(Appendix ORD: 12.2.3B)

Draft Local Development plan – Lot 2 Banksia Road Crooked Brook

As the nearest residents to the development, we would like to make a submission & comment on the draft development plan proposal.

SITE PLAN

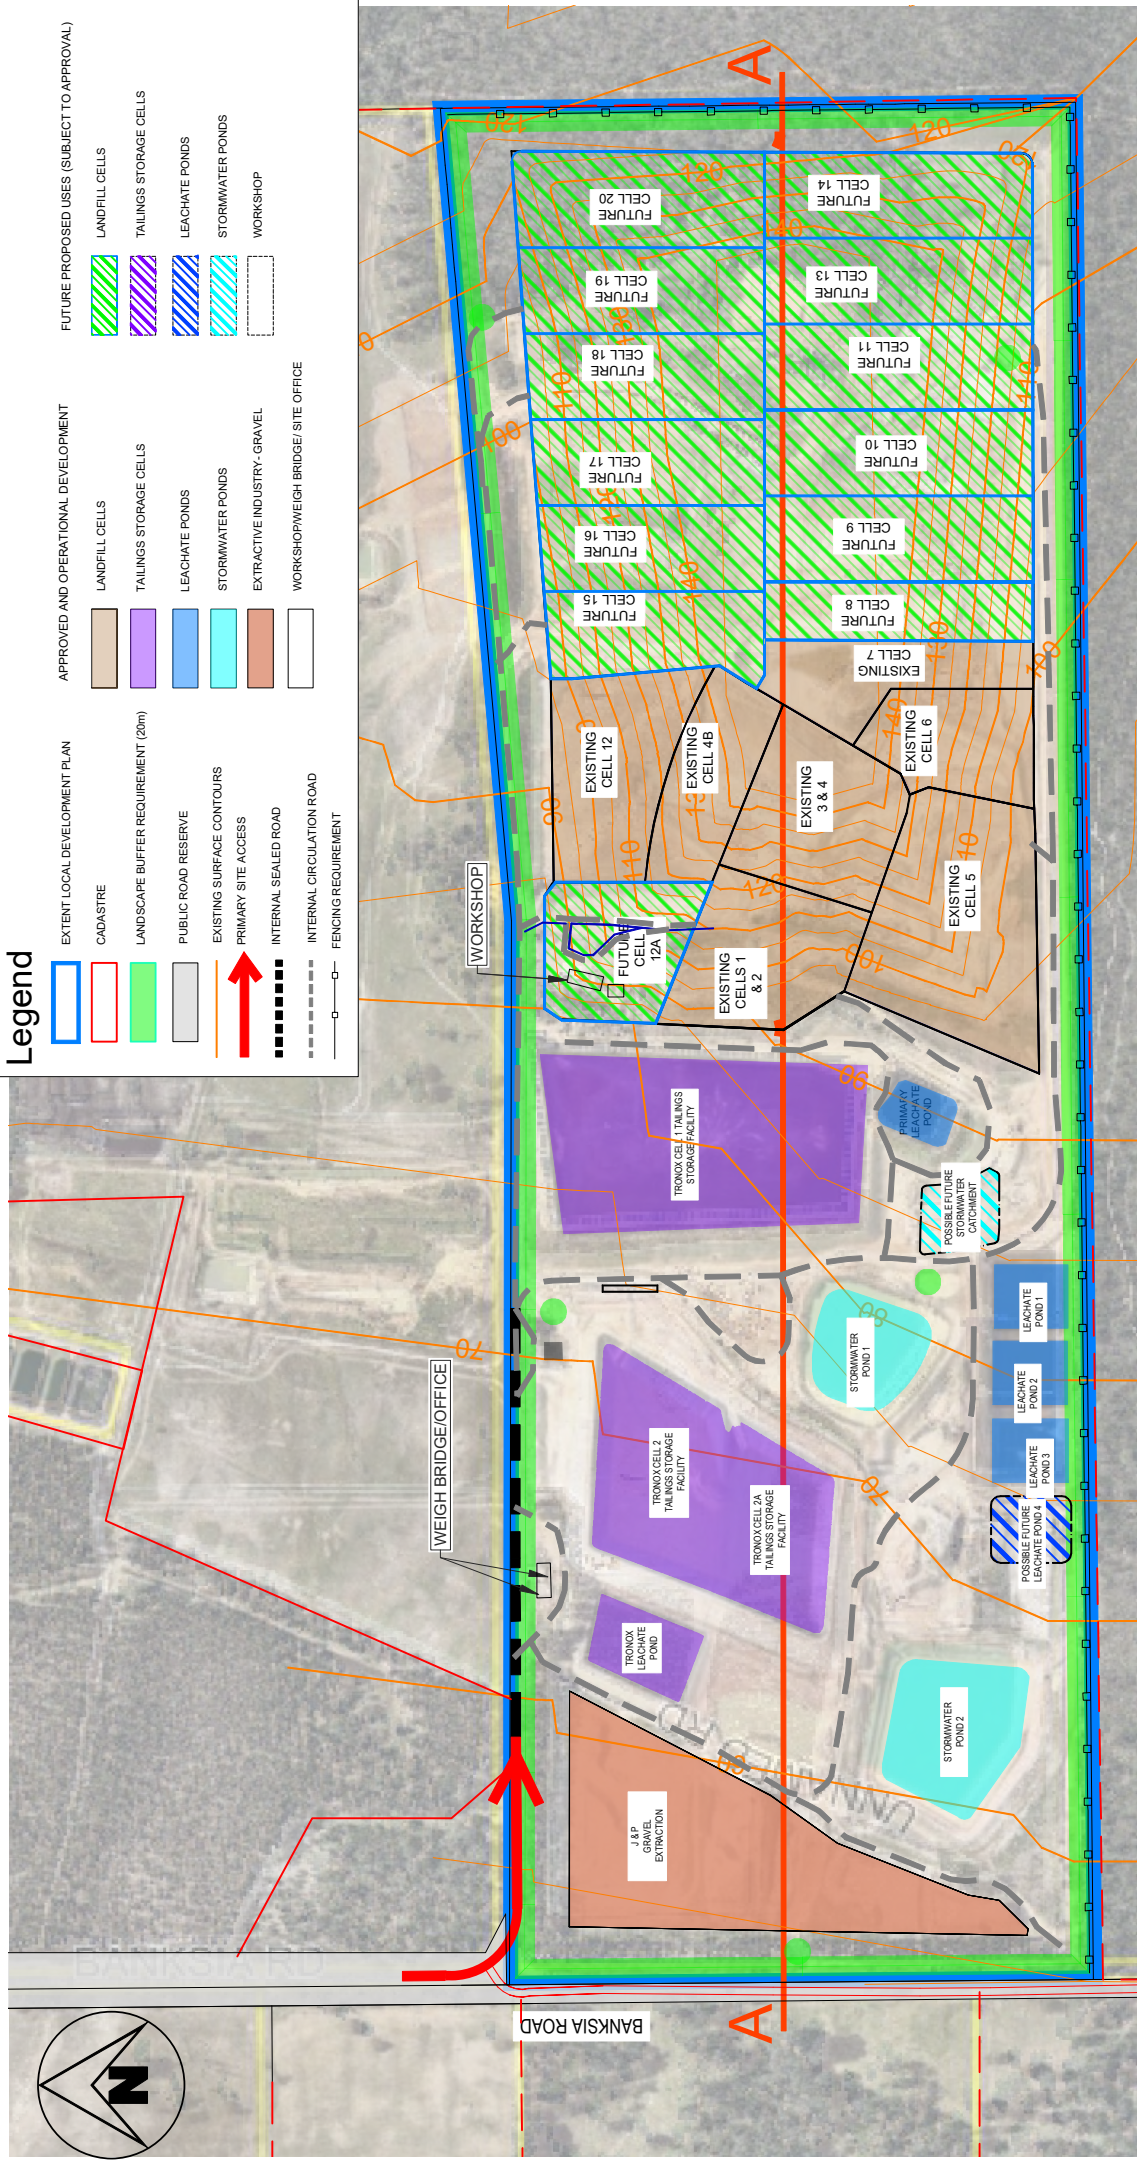
Cleanaway requests that this wording be amended to state, 'Development is not to exceed a maximum height of 151m AHD (top of waste 149m AHD, plus 2m capping), as outlined in the Cross Section.' It is noted that the cross section itself as well as the contours on the 'Site Plan' would then also need to be updated on the LDP.

Under the 'Landscaping Requirements' stated on the advertised LDP, the requirements reference a 'minimum 20m landscaping strip adjacent to the subject site boundary'. Again, Cleanaway's request is to amend this wording to provide flexibility to this 20m landscaping strip requirement, since some sections of this landscaping strip will need to be less than 20m wide and/or have already been approved with a slight reduction in width.

Secondly, the 'Landscaping Requirements' stated on the advertised LDP also require, 'Native tree plantings at a minimum size of 30 litres with a minimum mature height of 10m.' This should not be an absolute requirement which is stated in the LDP, but again should be more flexible, since this is normally detail that forms part of a Landscaping Plan. The tree size and height should therefore be deleted from the LDP and reference should be made to endorsement of a Landscaping Plan for the relevant portions of the site.
